Subject: LaSalle County Station Units 1 and 2
Mark II Containment
NRC Docket Nos. 50-373/374

Subject: LaSalle County Station Units 1 and 2
Mark II Containment
NRC Docket Nos. 50-373/374

INSTRUCTIONS FOR UPDATING YOUR MARK II DAR

C.0 LA SALLE DESIGN BASIS VS. NRC LEAD PLANTACCEPTANCE CRITERIA

FIGURE D.1-1

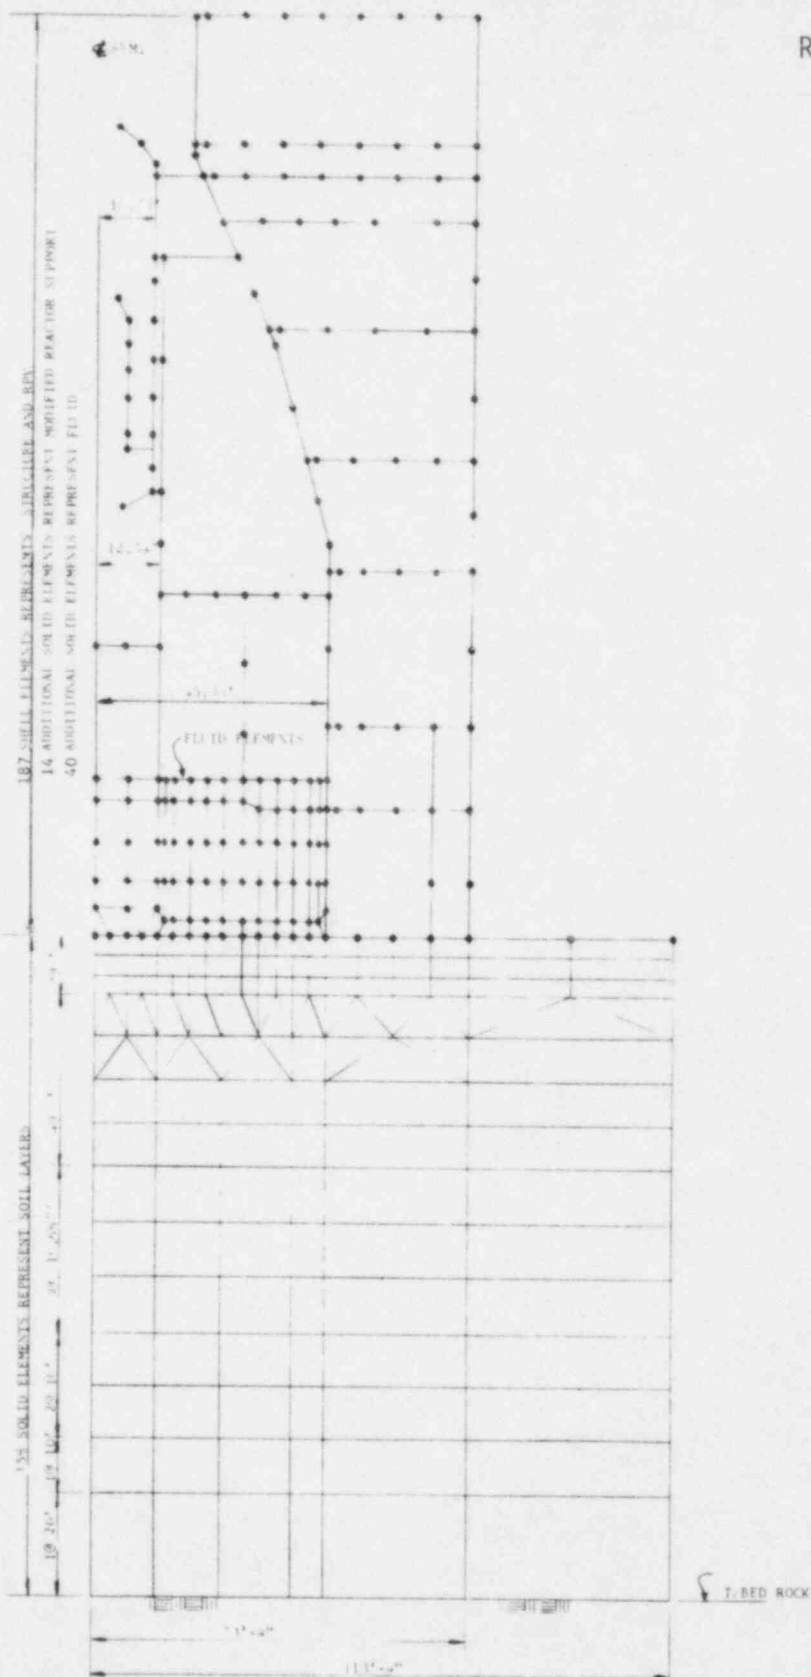
A plant unique FSI analysis has been performed to determine the actual FSI-inclusive forces and moments.

Figure D.1-1 shows the refined structural analysis model which includes the containment wall, the basemat, the founding soil, and the fluid in the pool. The fluid is simulated by fluid finite elements described in Reference 2. Dynamic analyses for SRV and LOCA chugging loads were performed using this plant unique FSI analysis model and the analysis procedures

described in Subsections 5.1.1 and 5.1.2 of the Closure Report. The resulting forces and moments in the structure include the actual plant unique FSI effects. FSI does not necessarily amplify the wall forces, but also tends to reduce them, depending on the dynamic characteristics of the structure and the loading. These forces and moments are combined with other loads in the load combinations defined in Table 4.1-1 using the conservative ABS method, even though the SRSS method is more appropriate.
